Access Compliance Report

Public Rights-of-Way

Intersection ID: 3620	Main Street: BROWNE'S_FERRY_RD	Cross Street: HUNTER'S_SPRING_DR	Location:	N
ADA ID: 89E8B7B3E406	Ramp Type: Perp	Initial Pass/Fail: Fail	Overall Compliance: No	Severity Score: 10
Codes/Mitigation Info/Possible Solution		Field Measurements/Component Compliance

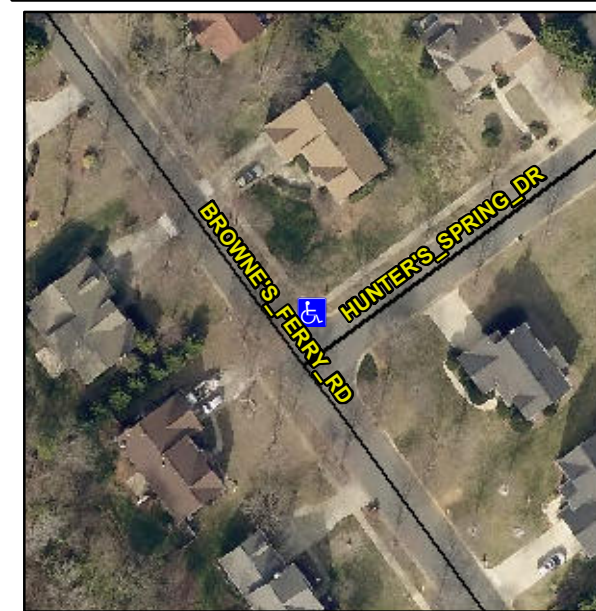
Remove & Replace Entire Ramp.

Not Found, R304.5.1

Compliance	Description	Data	Compliance	Description	Data
N/A	Ramp Length (in)	62.0	Yes	Ramp Slope (%)	5.5
No	Ramp Width (in)	36.0	Yes	Ramp XSlope (%)	4.0
N/A	Flare Type LT	N/A	N/A	Flare Type RT	N/A
N/A	Flare Slope LT (%)	N/A	N/A	Flare Slope RT (%)	N/A
N/A	Flare Traversable LT?	N/A	N/A	Flare Traversable RT?	N/A
N/A	Landing Length (in)	N/A	N/A	DWS Provided?	N/A
N/A	Landing Width (in)	N/A	N/A	DWS Contrast?	N/A
N/A	Landing Slope (%)	N/A	N/A	DWS Length (in)	N/A
N/A	Landing X Slope (%)	N/A	N/A	DWS Full Width?	N/A
N/A	Landing Curb? (Y/N)	N/A	N/A	DWS Offset (in)	N/A
N/A	Shared Landing?	N/A			
N/A	Gutter Ponding?	N/A	N/A	Gutter Slope (%)	N/A
N/A	Gutter Lip Ht (in)	N/A	N/A	Gutter X Slope (%)	N/A
N/A	Painted X Walk1?	No	N/A	Painted X Walk2?	N/A
	X Walk 1 Direction	To SW		X Walk 2 Direction	N/A
N/A	X Walk 1 Width (in)	N/A	N/A	X Walk 2 Width (in)	N/A
	X Walk 1 Slope (%)	0.3		X Walk 2 Slope (%)	N/A
	X Walk 1 X Slope (%)	5.0		X Walk 2 X Slope (%)	N/A
